GROWTH MANAGEMENT DEPARTMENT STAFF REPORT
VILANO BEACH TOWN CENTER OVERLAY DISTRICT

October 11, 2023 Public Meeting
VBTCDR 2023-05 Vilano Mixed Use

Architectural Review Comments
Vilano Beach Town Center
Beach at Vilano
VBTC DR 2023-05

Prepared by
Donald A. Crichlow, AIA
FL. Lic. AR0015950
September 20, 2023

SITE PLAN

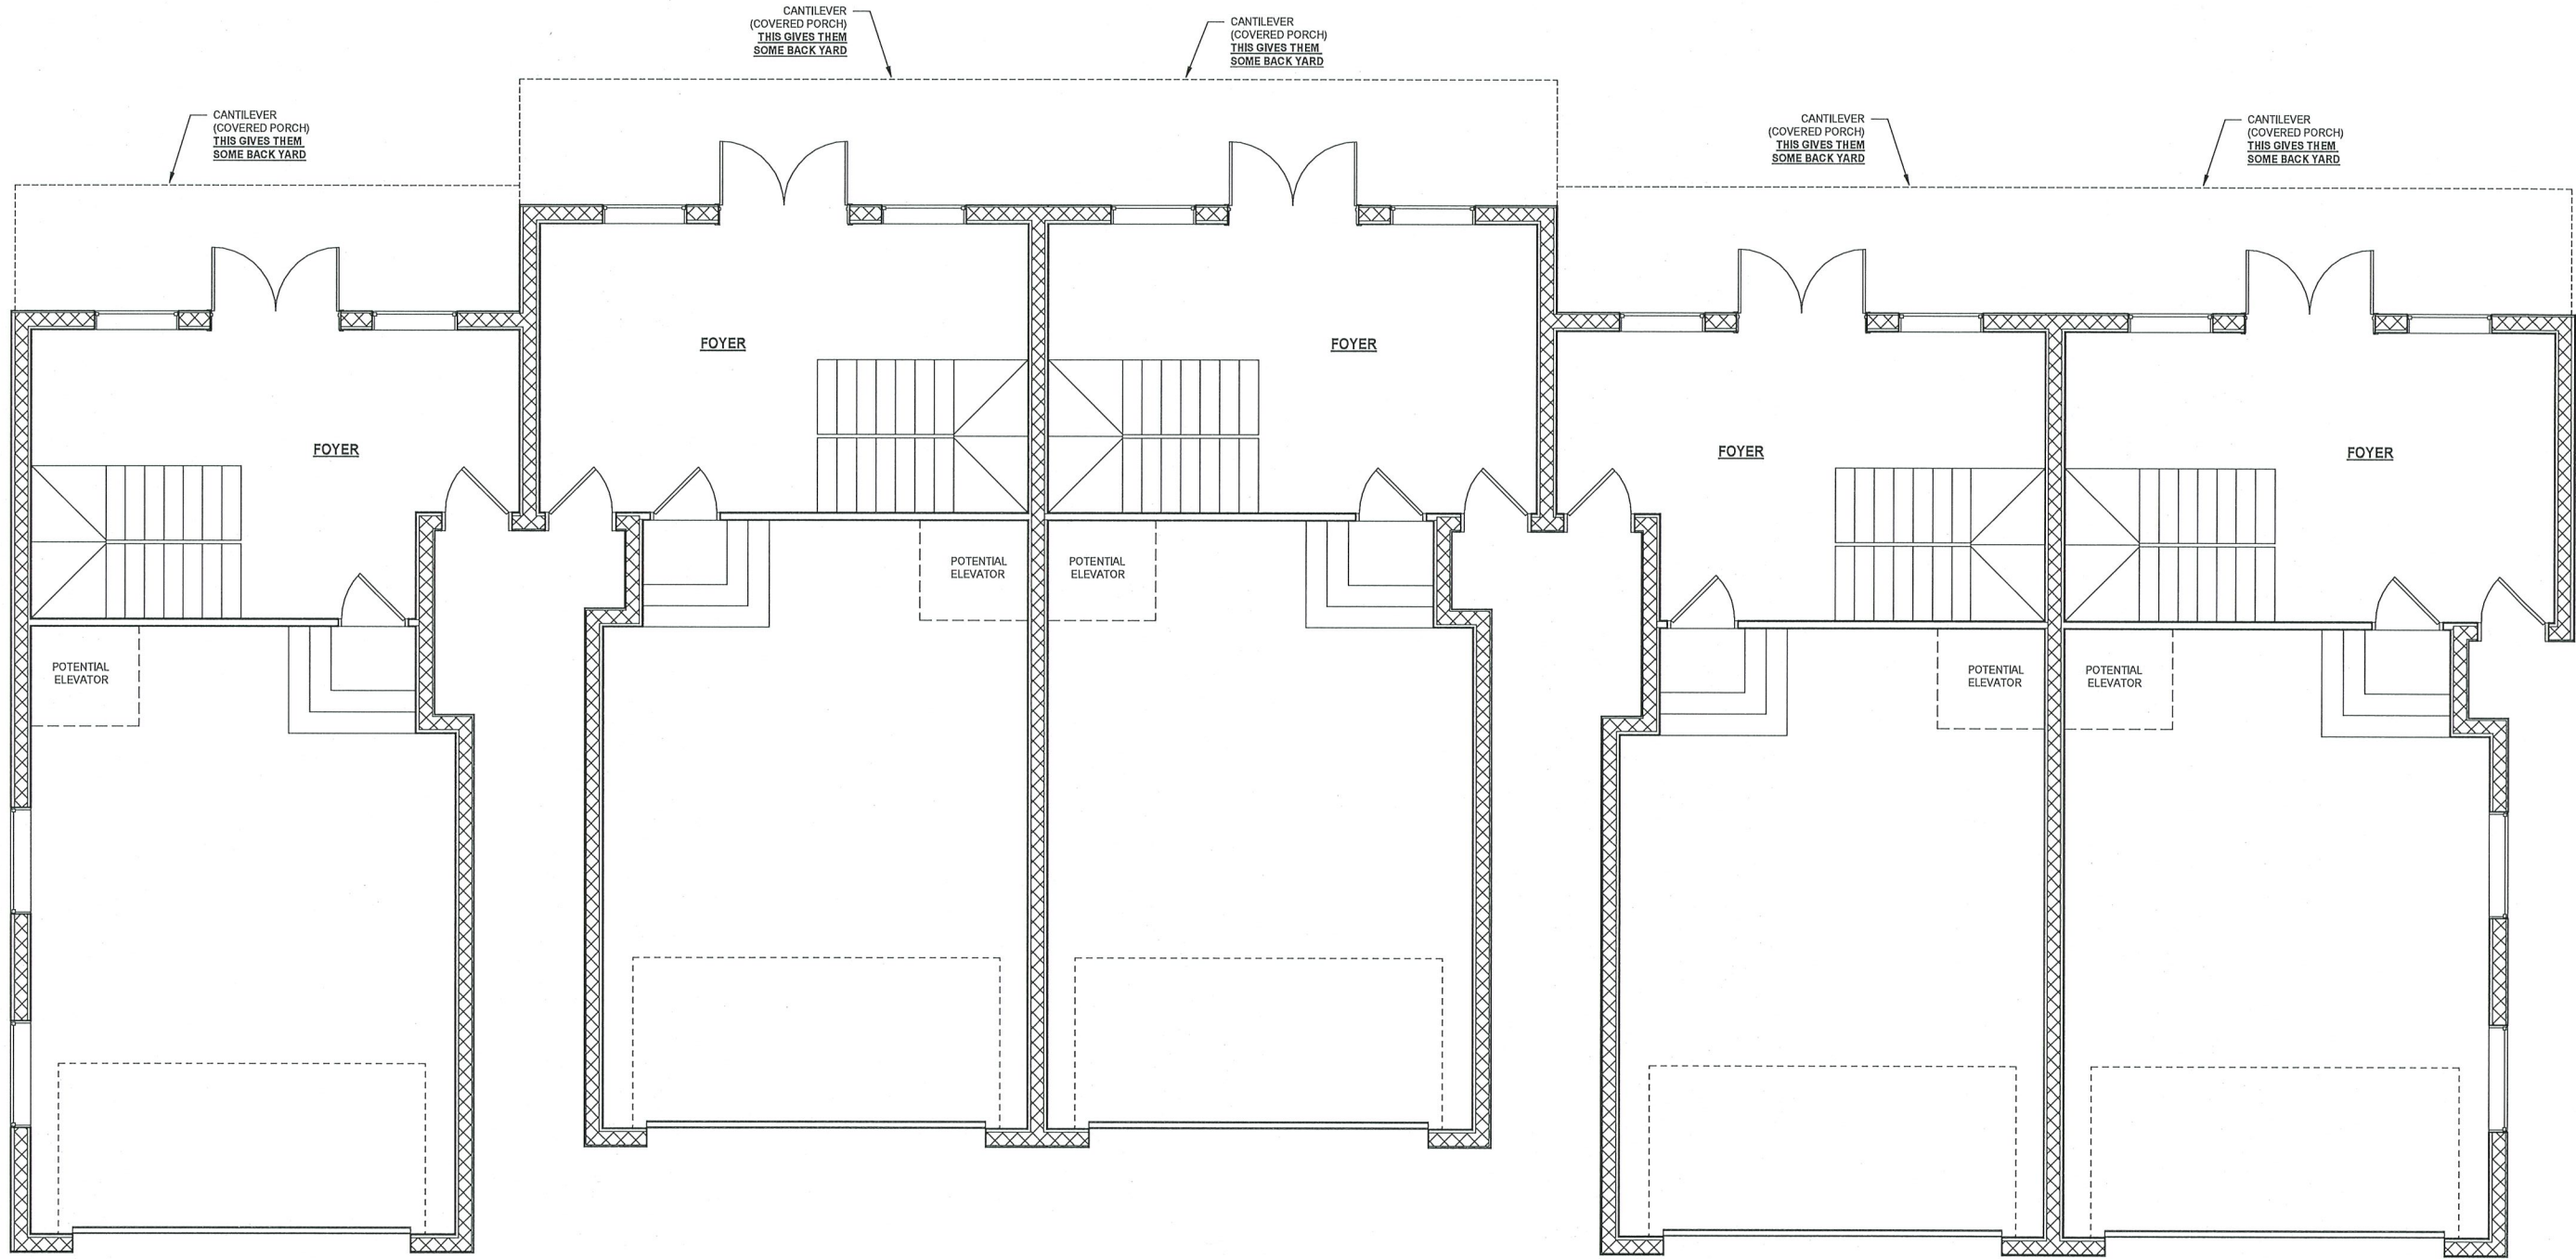
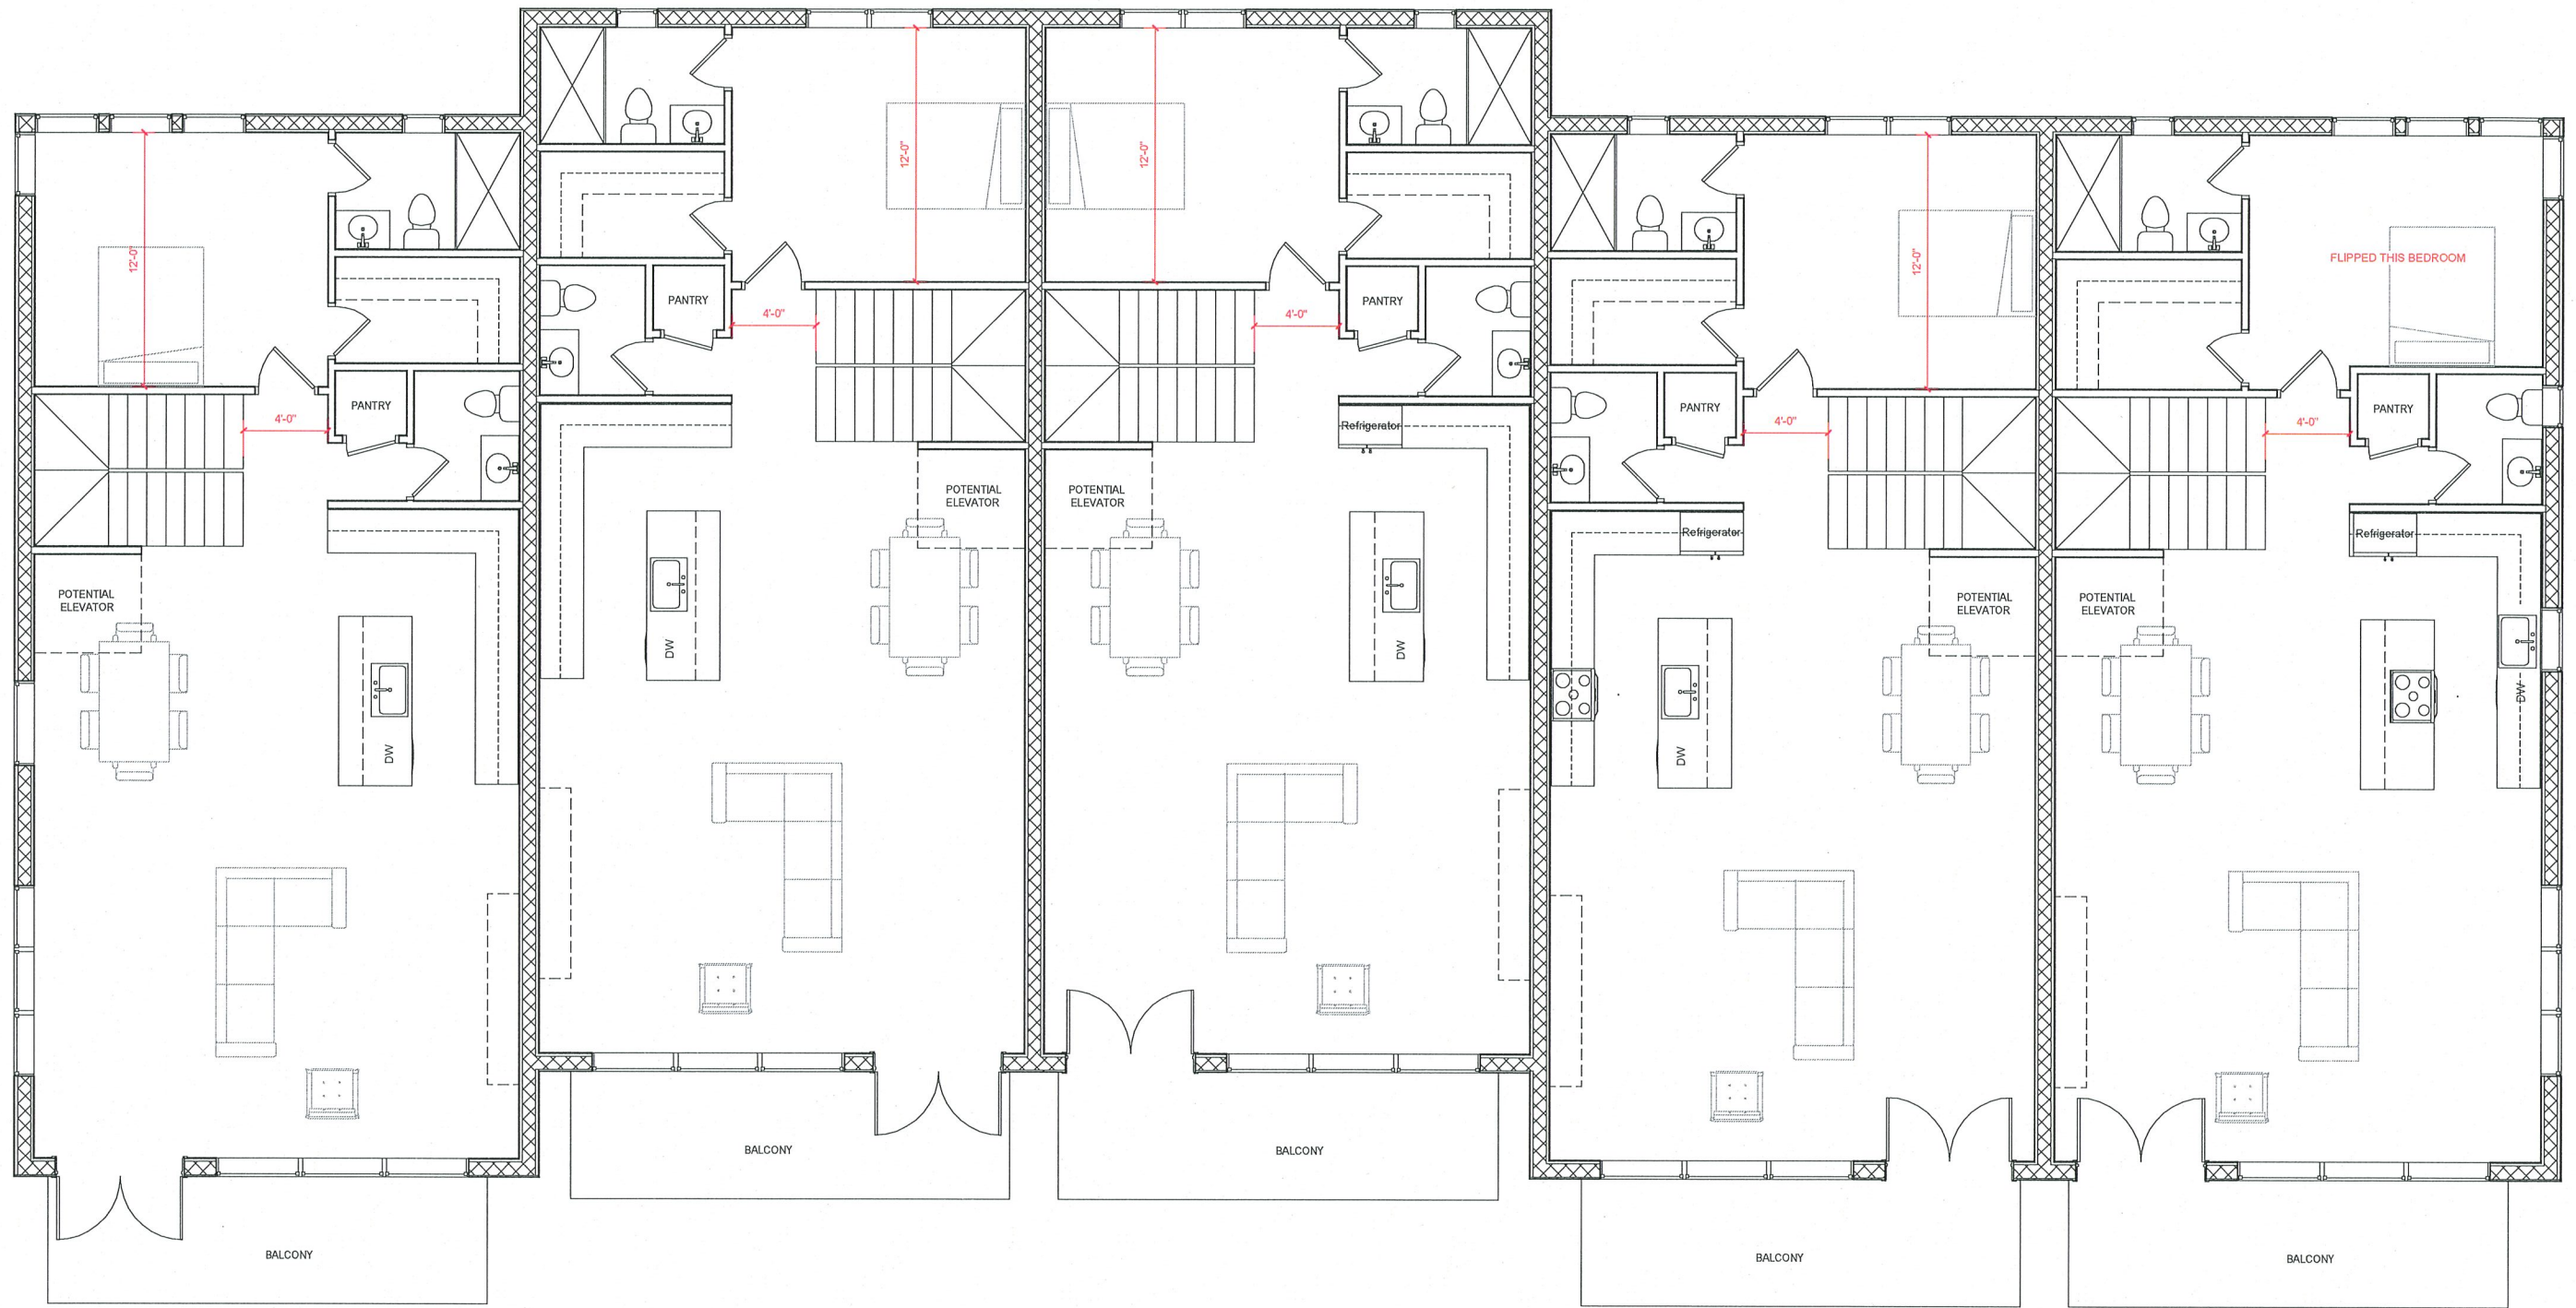
The plans show underground parking and garages with the multi-family units. The VBTC requires one space per dwelling unit. There are 16 multifamily dwelling units proposed requiring 16 spaces and four tourist homes proposed requiring four spaces. The site plan show sufficient parking for the residential units. The site plan depicts commercial parking, which is not part of this approval.

Section 3.10.04.A.9. Transmission, phone and cable boxes will be placed in the rear of the development and decorated in a manner compatible with the architectural style of the building. These utility elements are not shown on the site plan. The DRB may want to ask the applicant to provide where such utility elements are located and how those are screened.

Section 3.10.04.A.17. Accessways, driveways and access points are shown on the site plan.

Section 3.10.05.J. Parking. The plans show underground parking and garages with the multi-family units. The VBTC requires one space per dwelling unit. There are 16 multifamily dwelling units proposed requiring 16 spaces and four tourist homes proposed requiring four spaces. The site plan show sufficient parking for the residential units. Please note the site plan depicts the commercial parking, which is not part of this approval. Parking will be reviewed with the construction plans.
